UNITED STATES PATENT AND TRADEMARK OFFICE

APPLICATION NO.	FILING DATE	FIRST NAMED INVENTOR	ATTORNEY DOCKET NO.	CONFIRMATION NO.
10/672,772	09/26/2003	Mary Anne Alvin	2003PI4907US	9698

Office Action Summary

DETAILED ACTION

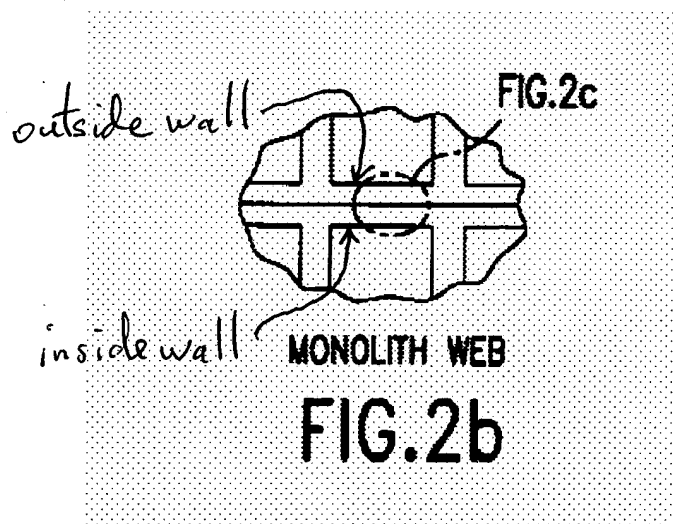
Claims 1 and 11 are rejected under 35 U.S.C. 102(b) as being anticipated by McCarty et al (US 6,015,285). See figure 2b reproduced below which shows a duct being formed by inside walls and outside walls. Both the inside and outside walls are lined with a barrier layer, and a catalyst is coated over the barrier layer.
